Addendum 1
City of Portsmouth
Bid # 61-17
Chestnut Street Streetscape Project

Issued: July 21, 2017

PROJECT:
CONGRESS & CHESTNUT STREET STREETScape & UTILITIES PROJECT
CONGRESS STREET TO PORTER STREET

TITLE:
UTILITIES PLAN B

SHEET NUMBER:
C-6

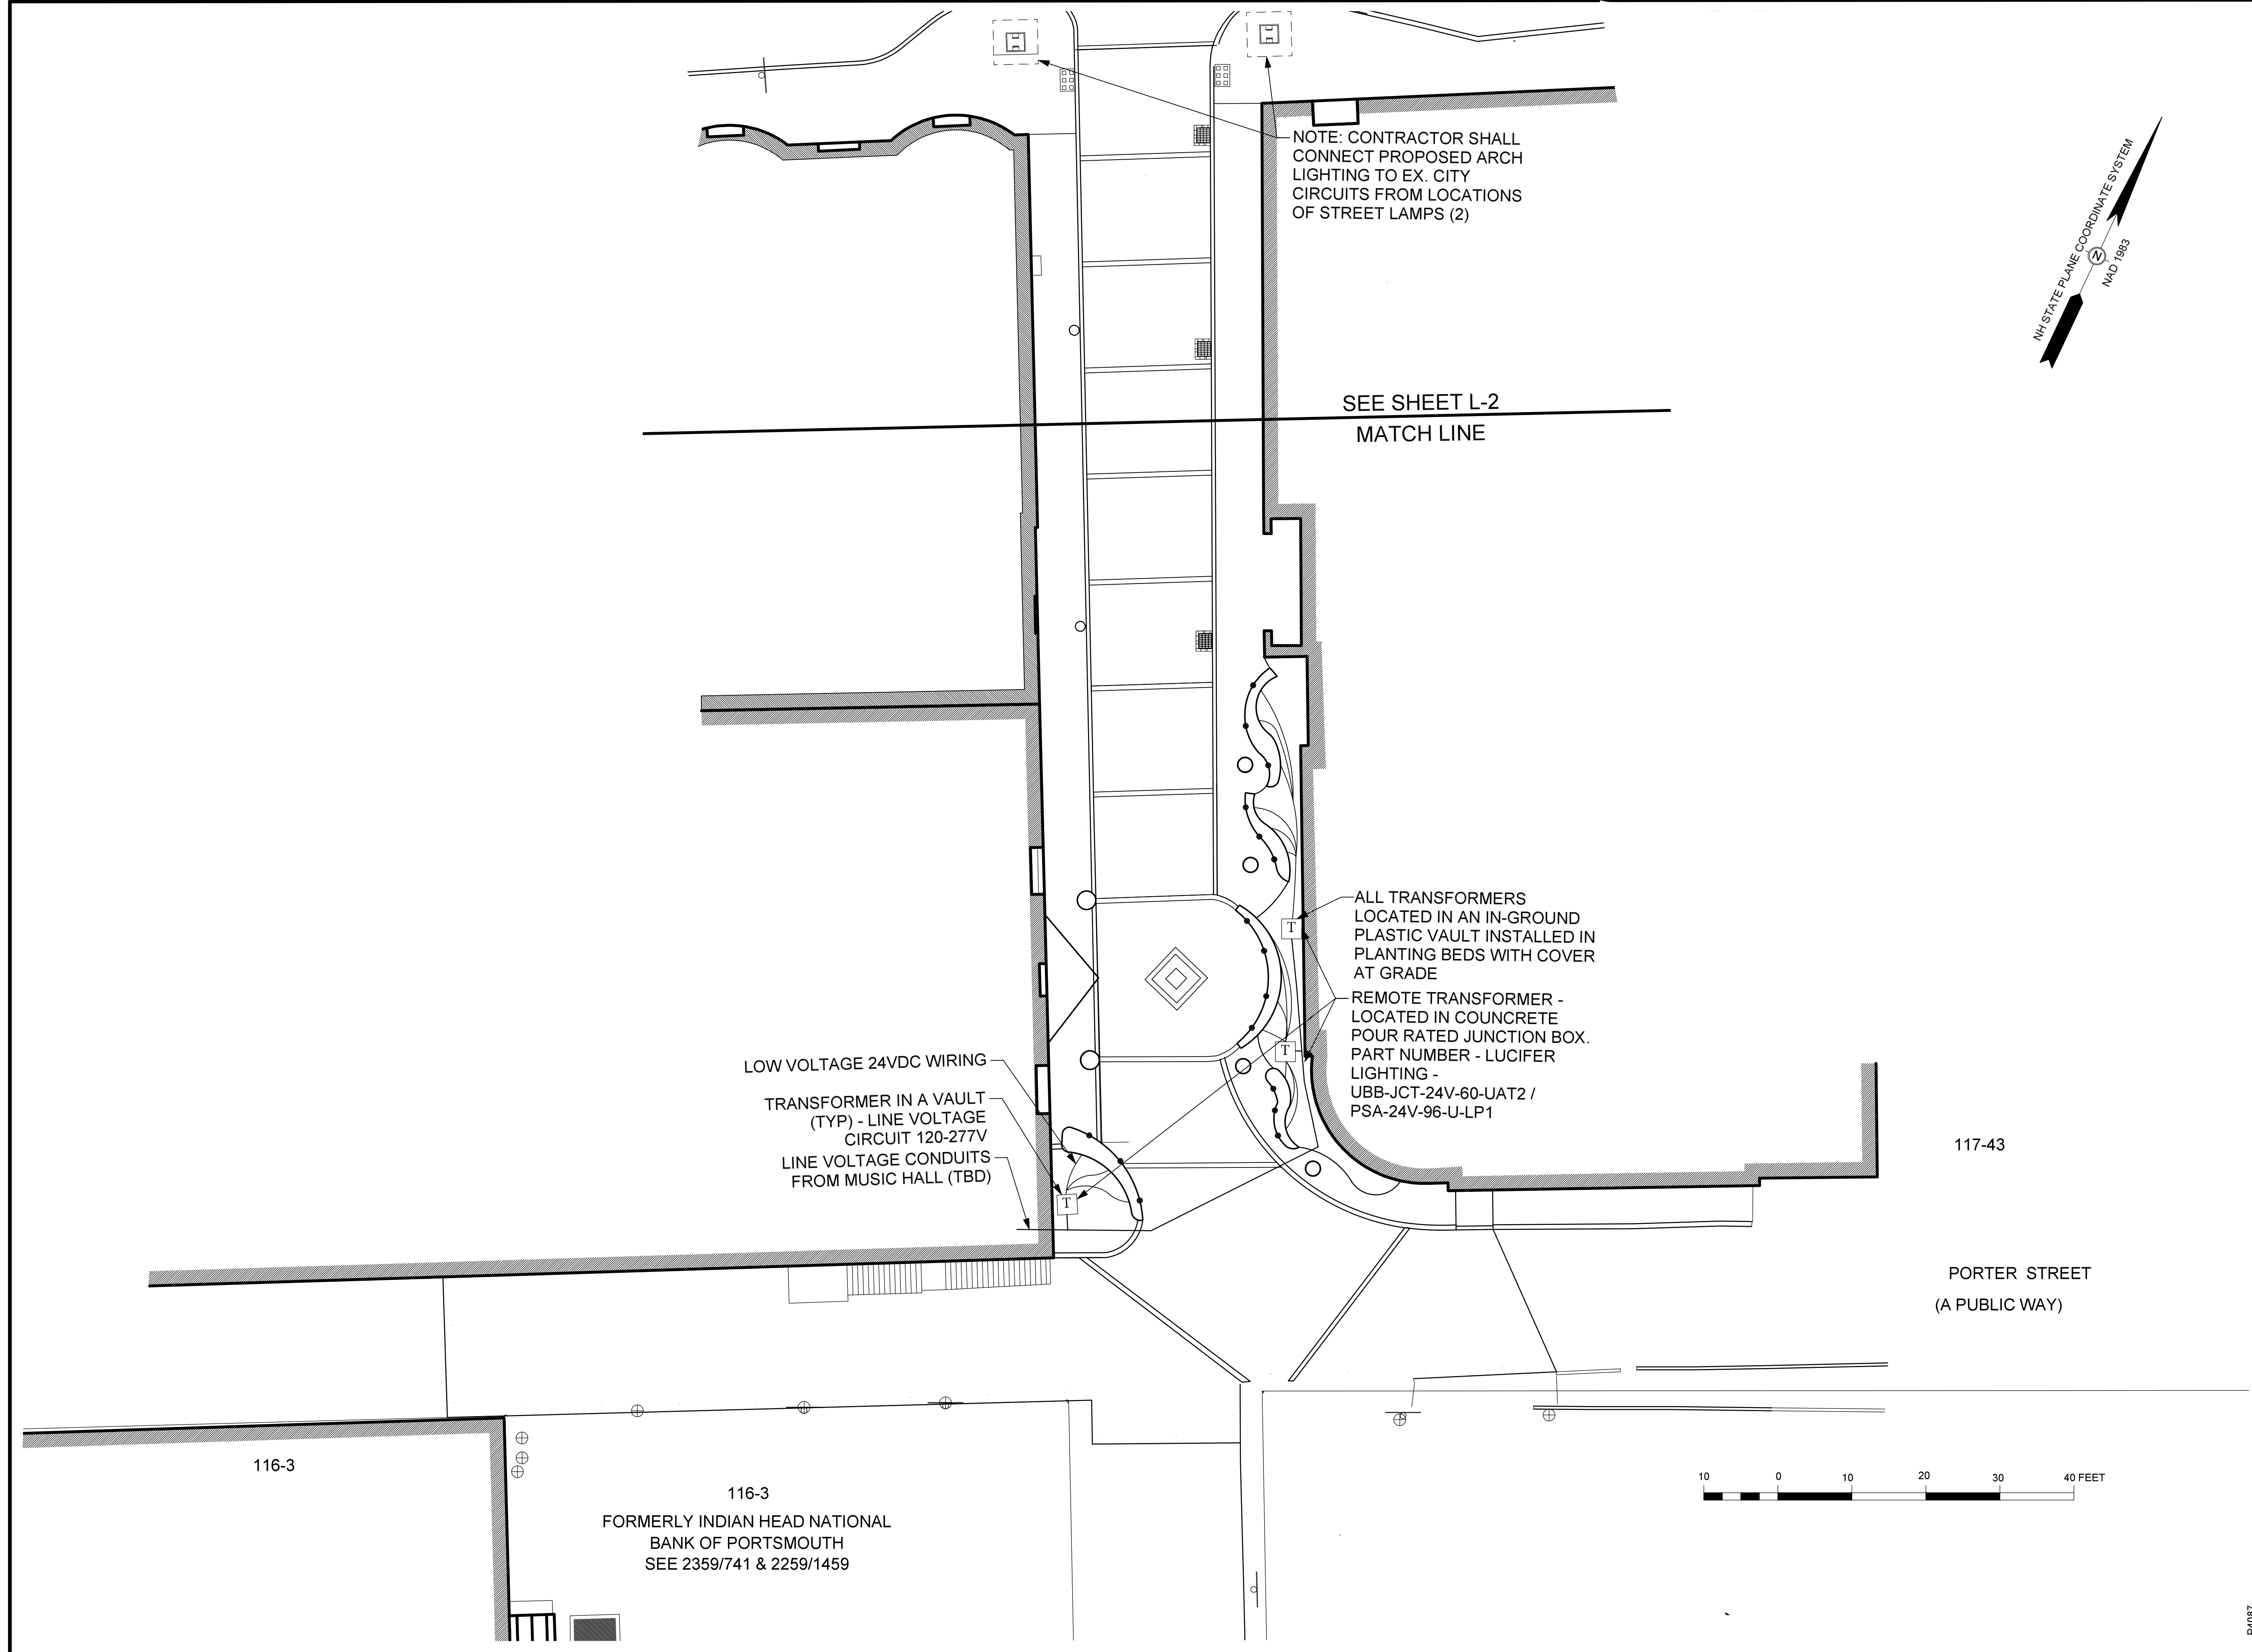
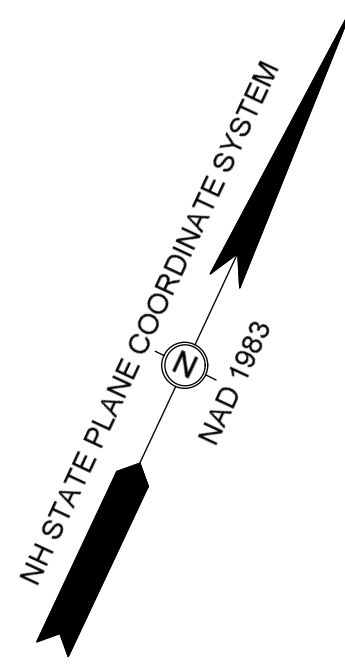
Clarification – Existing gas main in Congress Street will be terminated in Chestnut Street beyond the services to the Kearsage House and Mark McNabb's building services. The Music Hall gas service will be back fed from Porter Street. Thus, the gas main in the majority of the work limits can be abandoned during construction. Unutil has confirmed that their gas main can be installed after the other utilities have been installed. The sitework contractor shall be responsible for gas main trench excavation, bedding materials, backfill and compaction as well as coordination with Unutil. See attached sheet for additional details. See revised bid form for trenching.

GAS SERVICE TO REMAIN IN SERVICE DURING CONSTRUCTION
